December 1, 1982

SBN -394
T.F. B7.2.3

Subject: Supplemental Information on the Use of Steel H-Frame Structures
along the Seabrook to Newington Transmission Line Right-of-Way

— Steel H-Frame Tower —

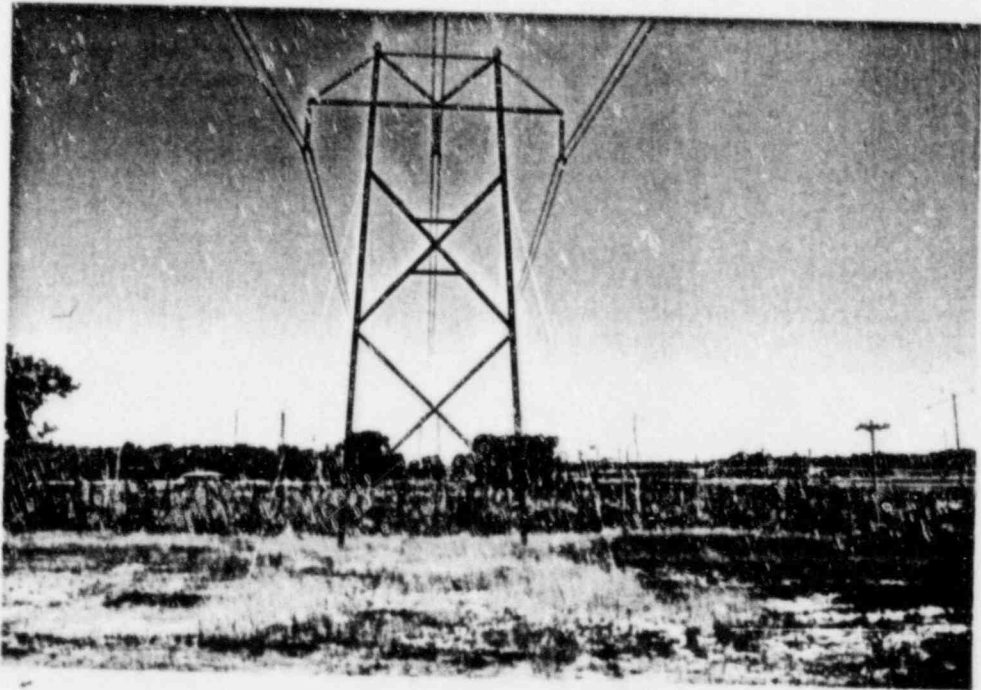
1. The use of steel permitted installation of H-frames with less bulk, making the structures appear less massive, hence reducing their visual impact. A comparison of critical dimensions of steel vs. wood is as follows:

2. The steel poles were set into the ground just as wood poles would be, thereby avoiding foundation work.
3. The life of steel structures is equal to or greater than wood with less maintenance. Wood structures must be inspected periodically and occasionally require ground-line treatment with wood preservatives. Wood pole maintenance would increase the travel over the right-of-way.
4. The weight of wood structures is about twice that of steel thus construction could be accomplished with smaller, lighter equipment.
5. The color of the steel structures is very much like that of treated wood, so their appearance is quite similar (see enclosed photos).
